**TOWN OF PORTOLA VALLEY
ARCHITECTURAL AND SITE CONTROL COMMISSION (ASCC)
Monday, March 25, 2013
Special Field Meeting (time and place as listed herein)
7:30 PM – Regular ASCC Meeting
Historic Schoolhouse
765 Portola Road, Portola Valley, CA 94028**

TO: ASCC
FROM: Tom Vlastic, Town Planner
DATE: March 21, 2013
RE: Agenda for March 25, 2013 ASCC Meeting

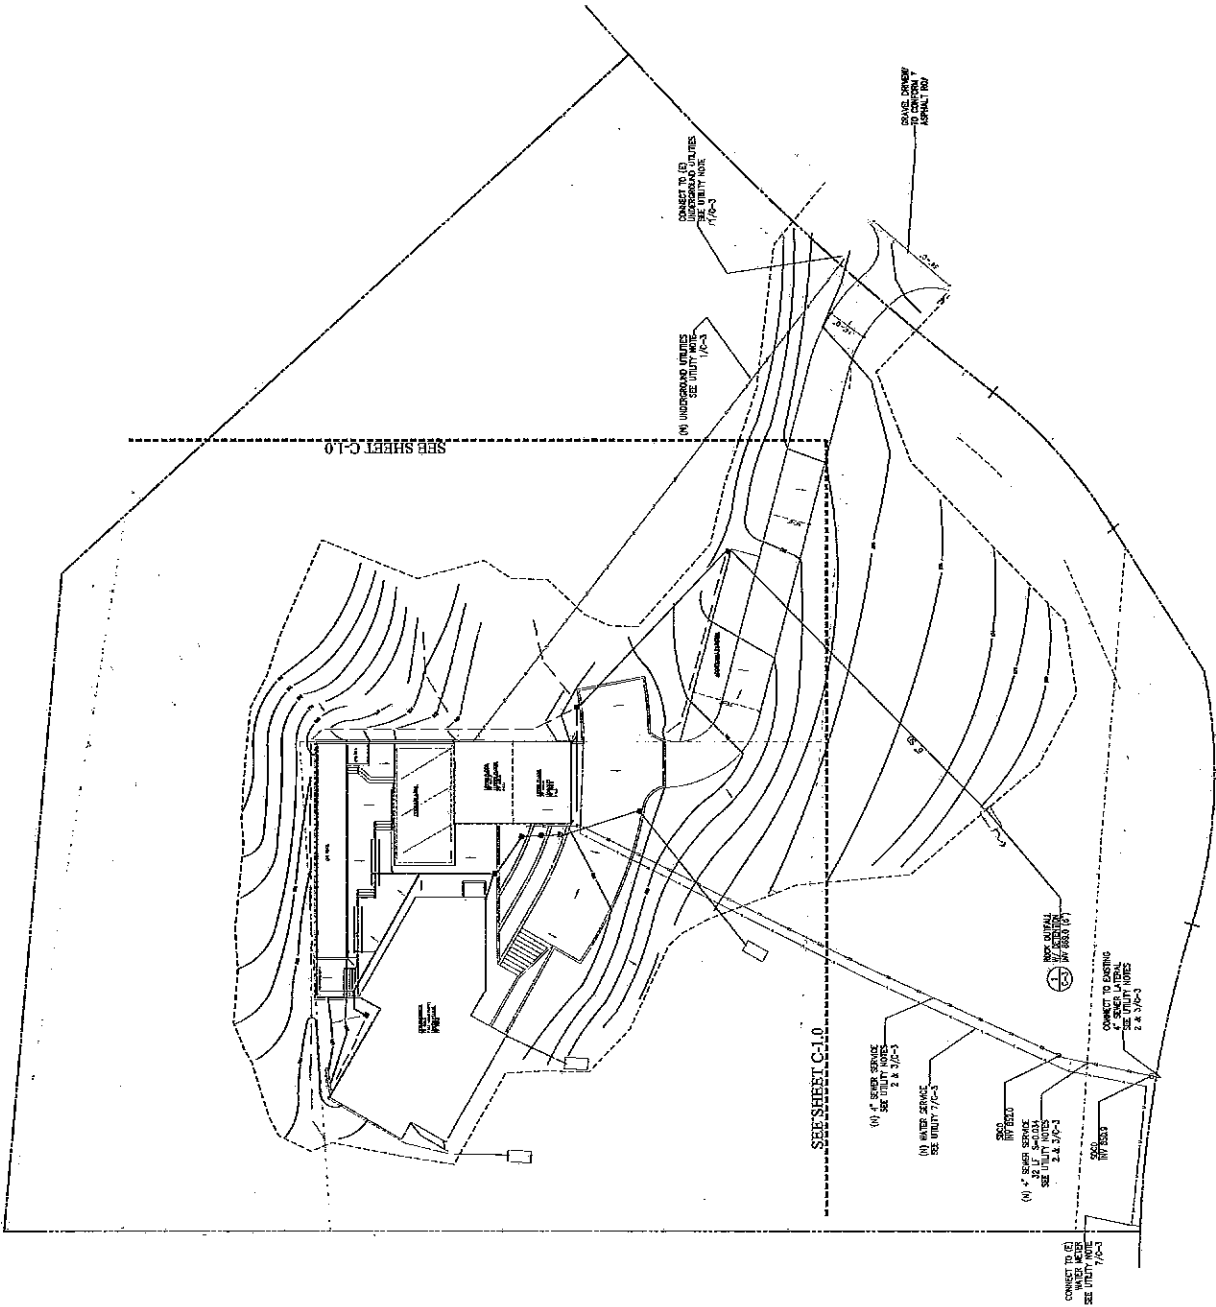
Attached are revised sheets C-1.0, C-1.1 and C-2.0 for review and use in the Planning Permit Process for 6 Buck Meadow Drive. The plans have been labled with a "delta 1 – Rev 03/18/13", but no clouding has been done to identify changes.

Per recent site walk and preliminary public meeting review, the directive was to present a grading plan that had balanced earthwork, to have no native soil "export". The attached plan has placed additional fill of 1 to 2 feet, below the proposed driveway and some additional fill to the north of the proposed home, to retain the necessary "cut" material on site. Grading limits were expanded approximately 8,000 sf, from pervious limits, to accomplish the balanced grading.

SITE LIGHTING
 SCALE 1" = 30'-0" (11x17 paper size)
 1" = 15' for 24x36 paper size

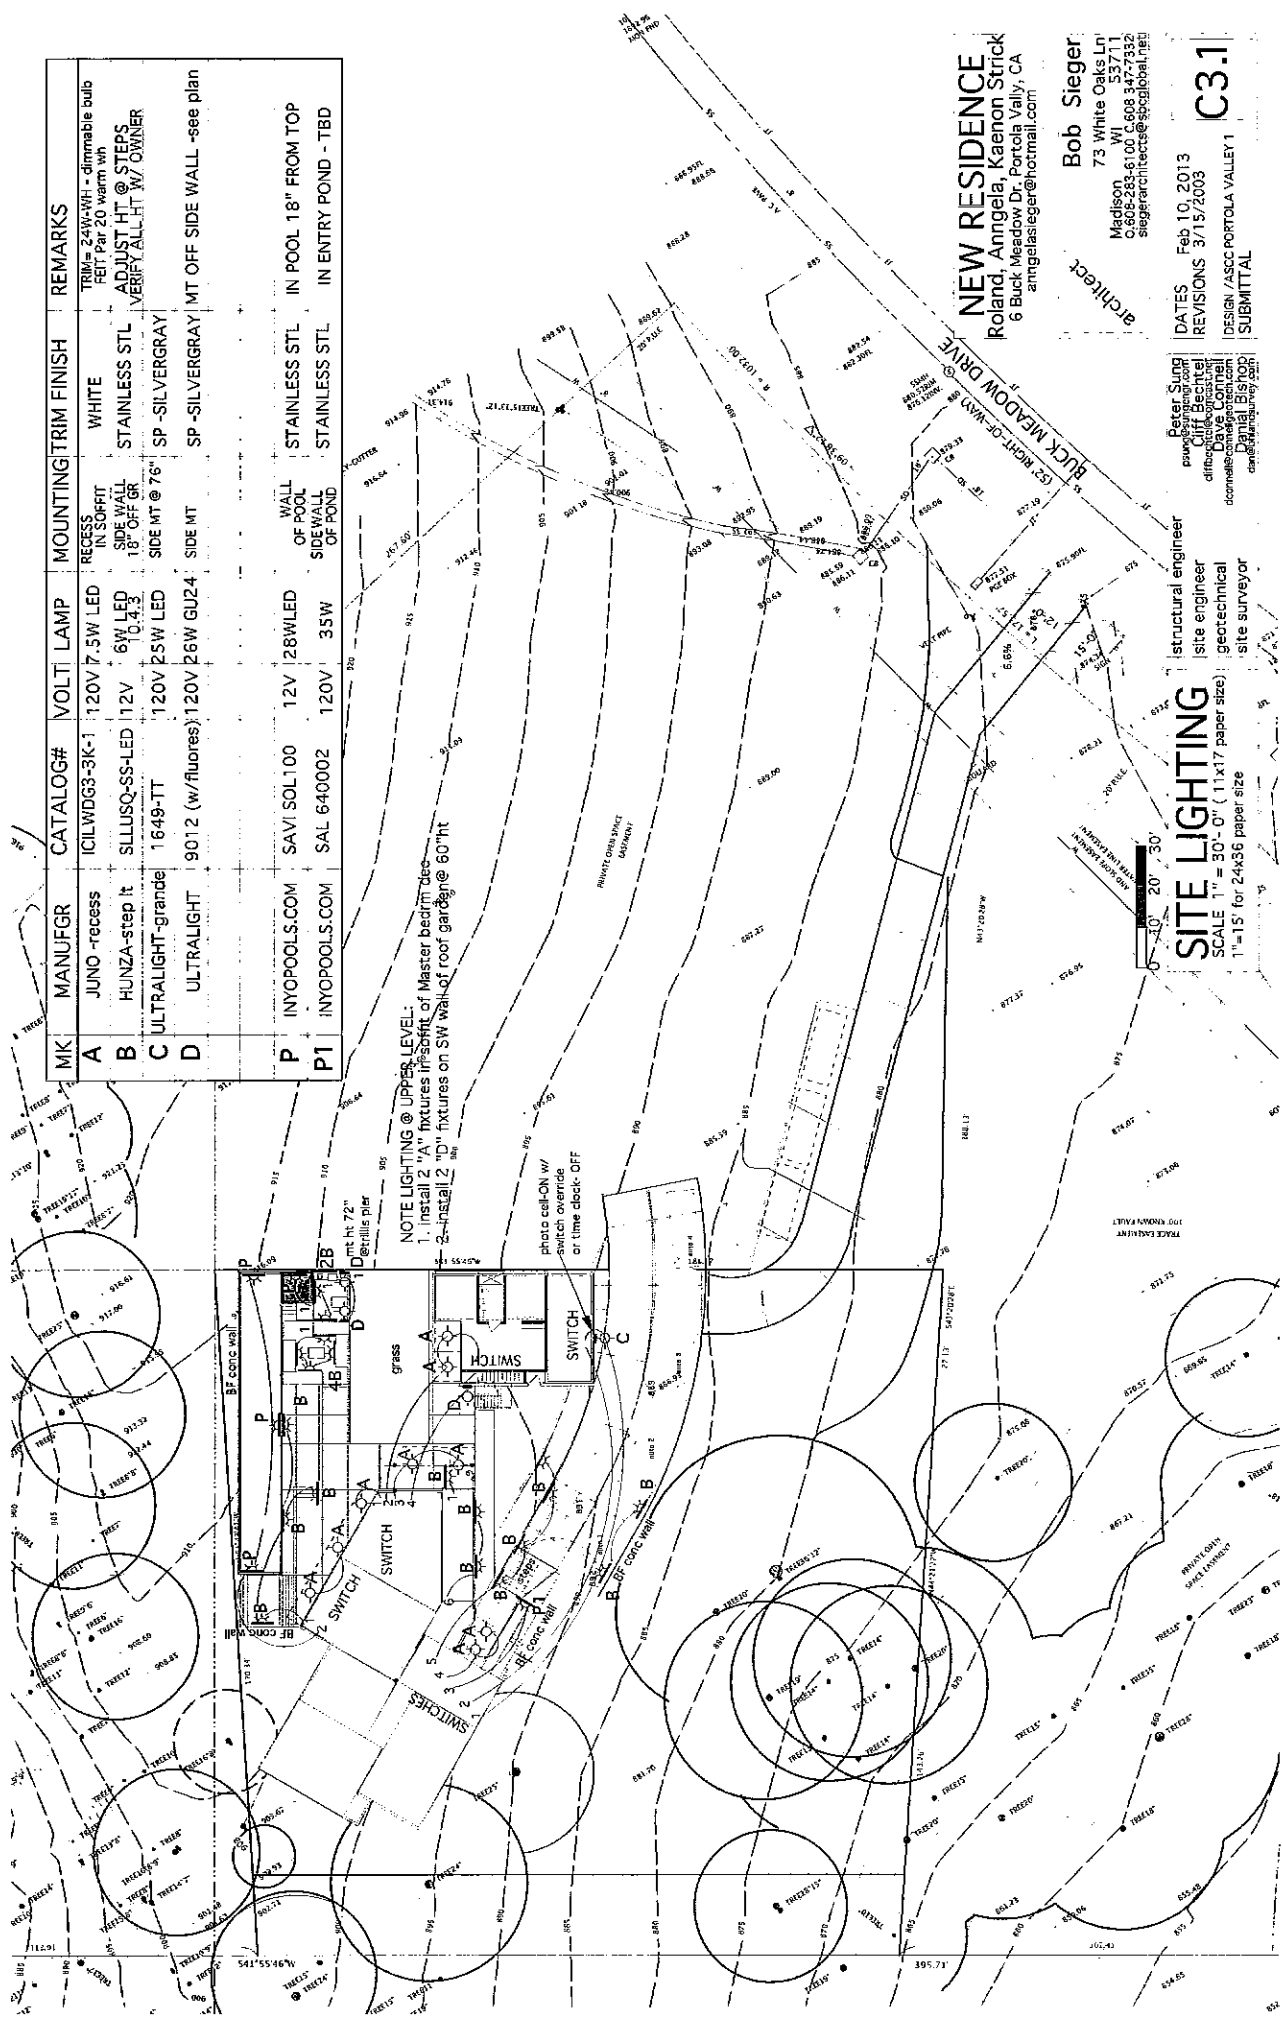
Are the lights shielded to prevent light pollution? There were no pictures of the fixtures on the plans we were given.

8. **Exterior lighting.** Proposed exterior lighting is shown on plan Sheet C3.1 and cut sheet for the proposed fixtures are attached. The plans appear to need the following adjustments to conform to town and Blue Oaks basic lighting standards and guidelines:

Our main design criteria for the outdoor lighting is to strive to eliminate light pollution to the natural outdoor night environment. Our plan has no lighting projecting upward or toward the sky.

A "cut spec sheet" on all lights has been submitted to the Town with the plans as an 8-1/2 x11 attachment. It is also attached to this letter.
